ARCHITECT'S SUPPLEMENTAL INSTRUCTION NO. 5

DATE: February 19, 2024 **PROJECT NO:** 230117

RE: Streets of West Pryor – Lot 5 Core & Shell

SHEET NUMBER
A-102

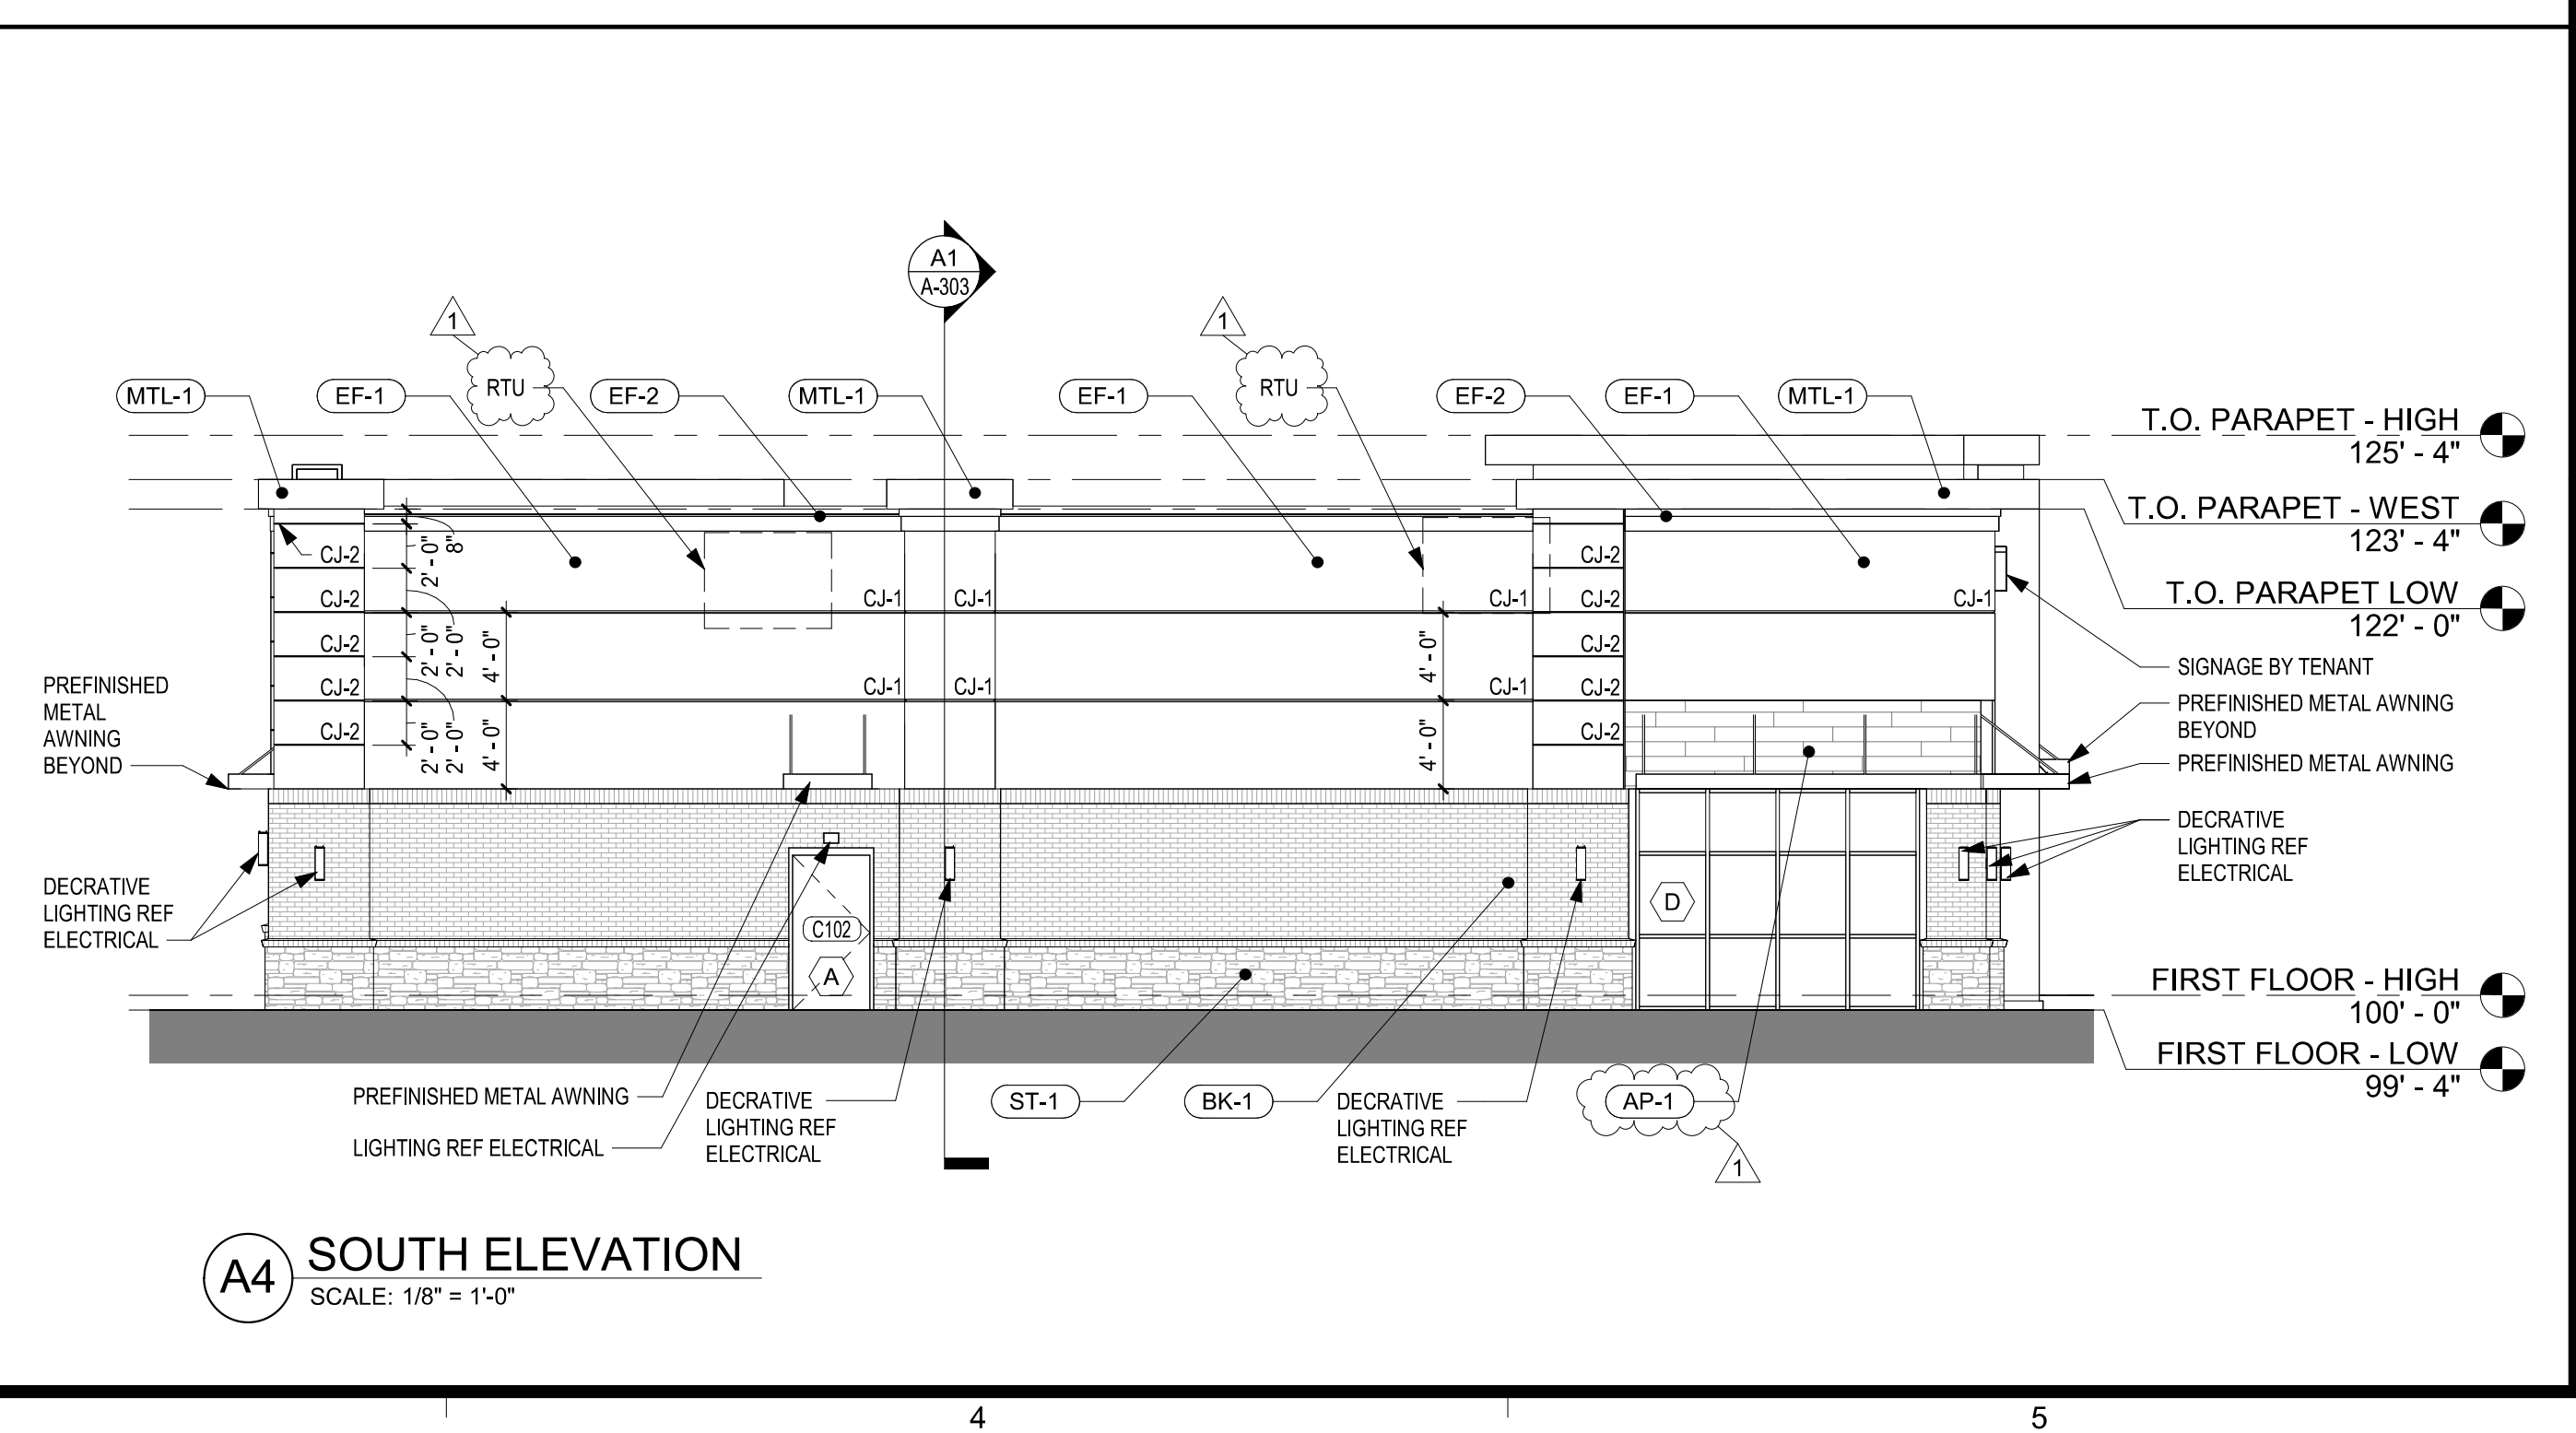
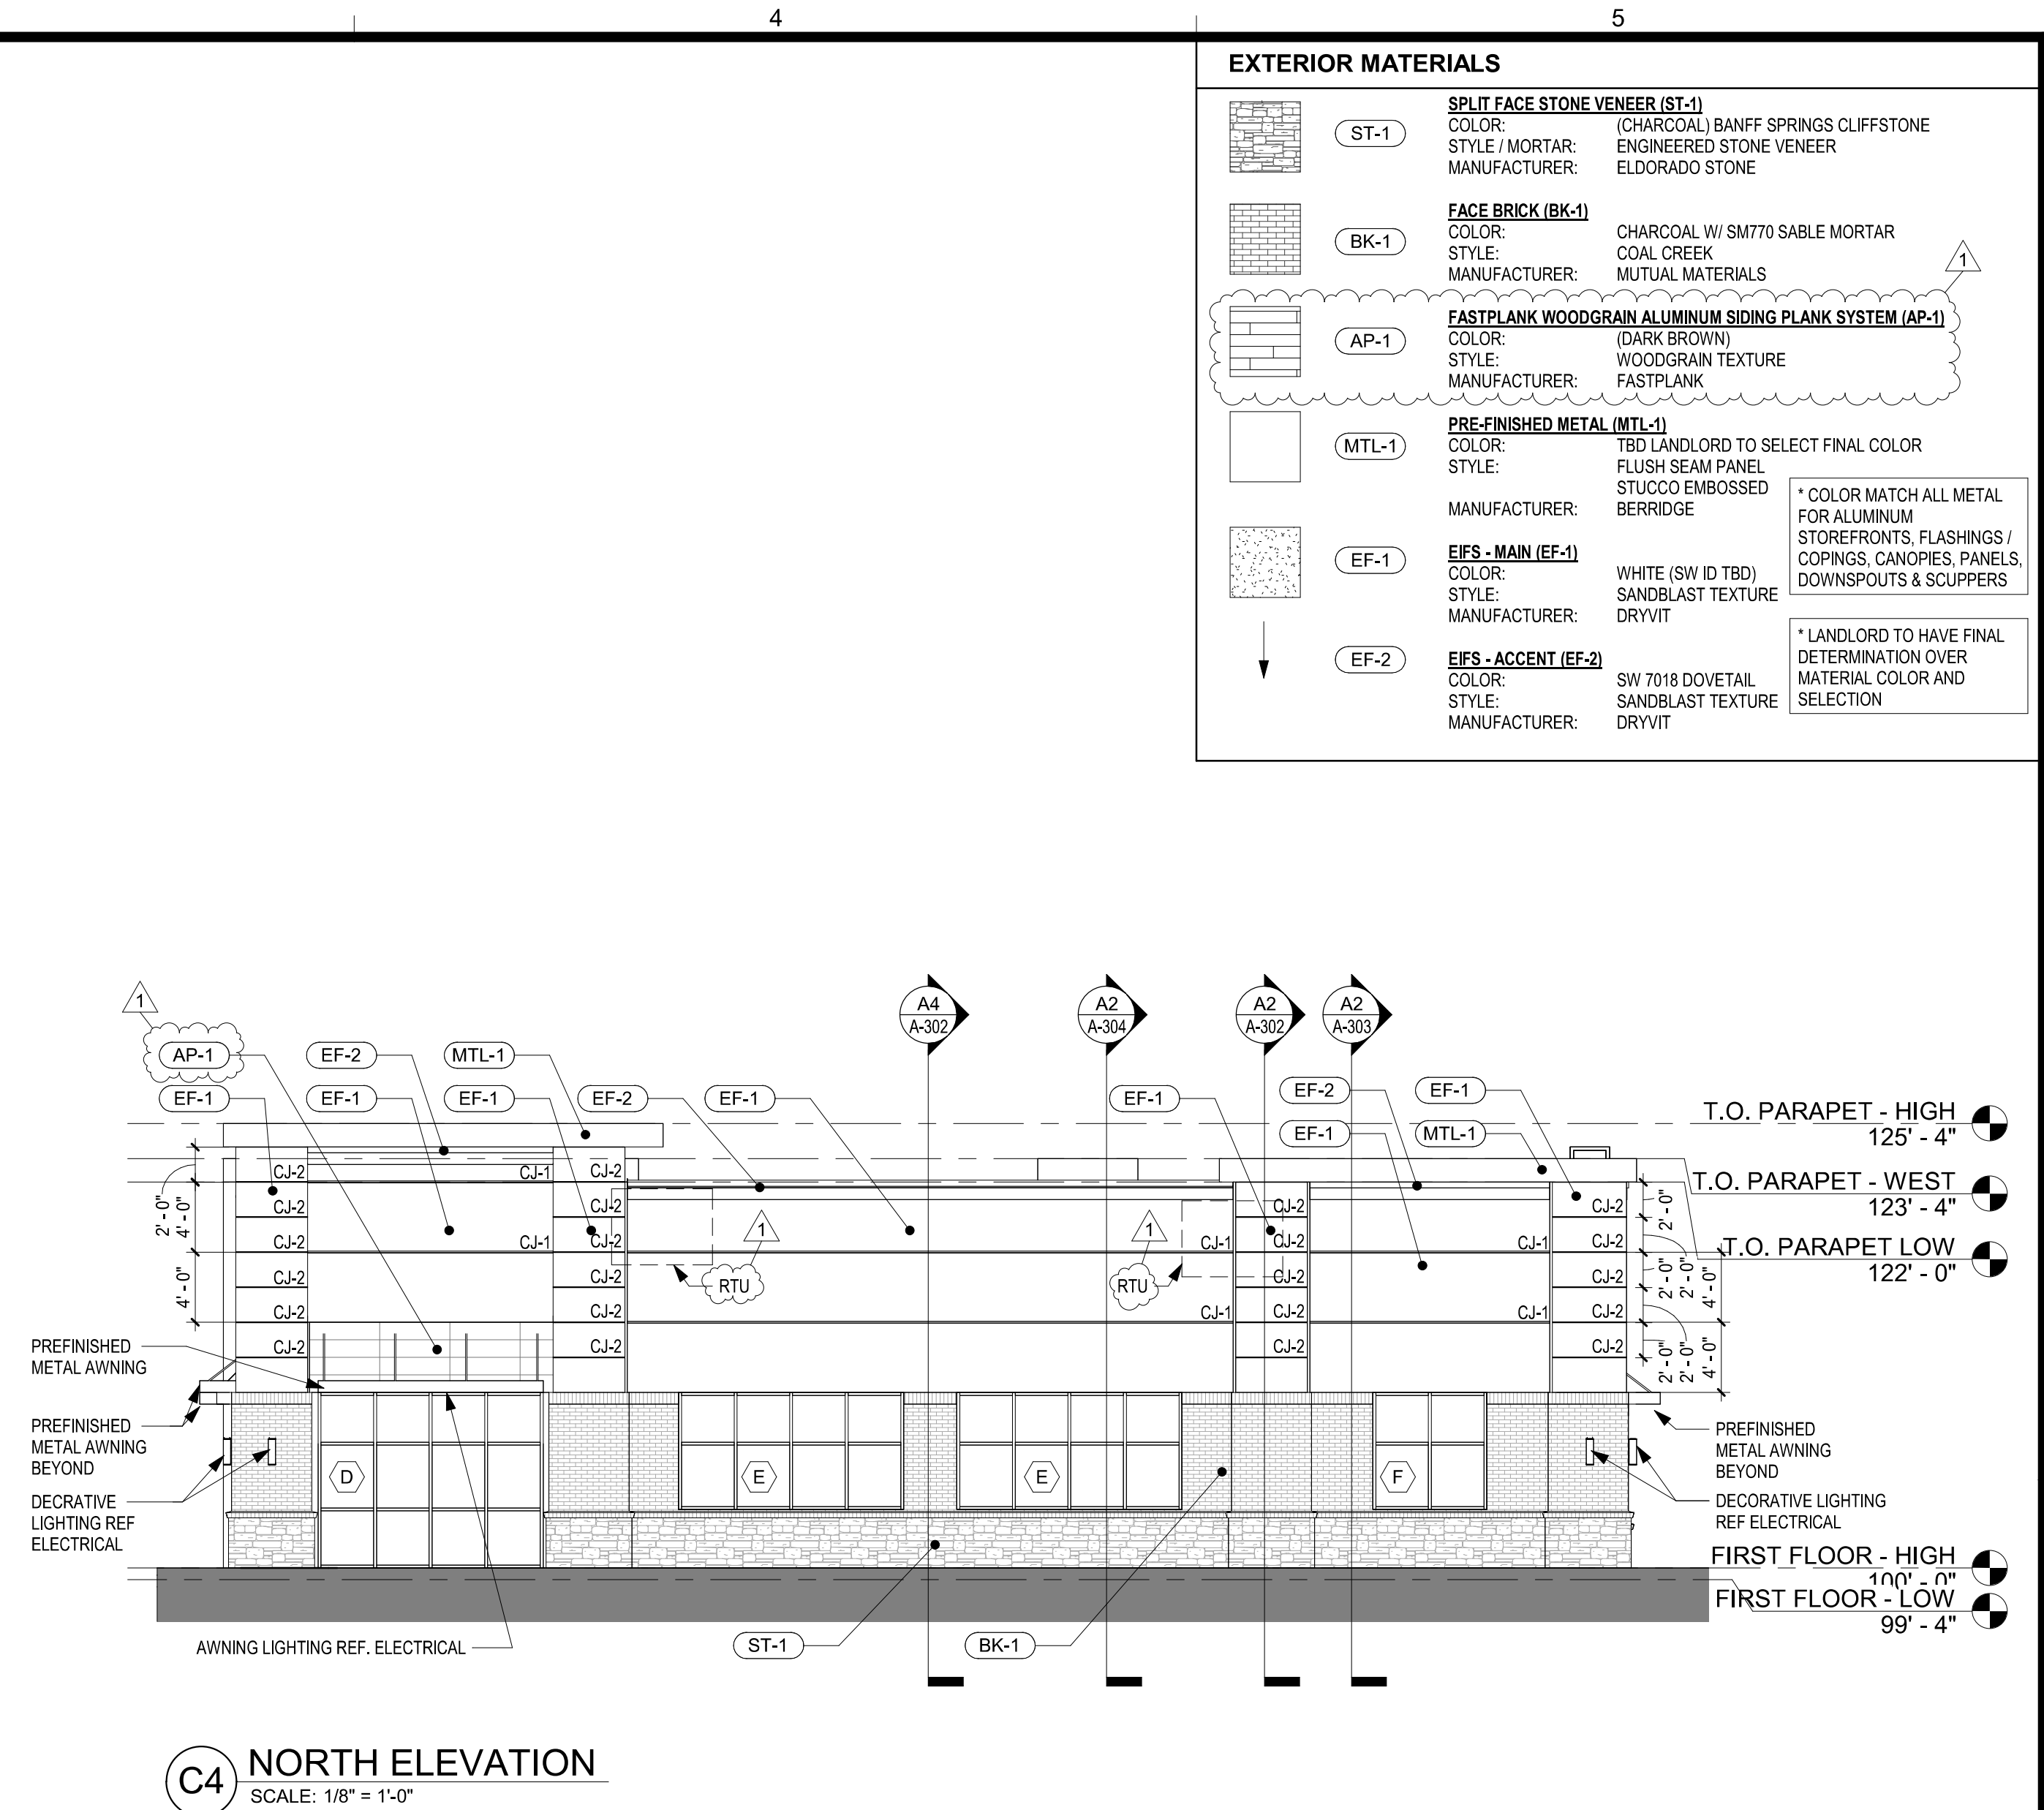
- A-1 Sheet G-001 – Code summary updated with usable square foot occupant load calculations and exit requirements for tenant suites A, B & C.
 - A-1.1 Sheet G-001 – Code plan updated with occupant load calculations and egress width for tenant suites A, B & C.
- A-2 Sheet A-101 – Two hour rated demising wall added to full East to West length of the building spaced 21 feet from face of gypsum board to the other second two hour rated demising wall. Creating and dividing the Core & Shell building into now three separate tenant suites.
 - A-1.A Updating tenant suite designations as Suite A, B & C respectively.
 - A-1.B Updating tenant suite square footage.
- A-3 Sheet A-102 – Roof Top Unit added to service enlarged Tenant Suite B space.
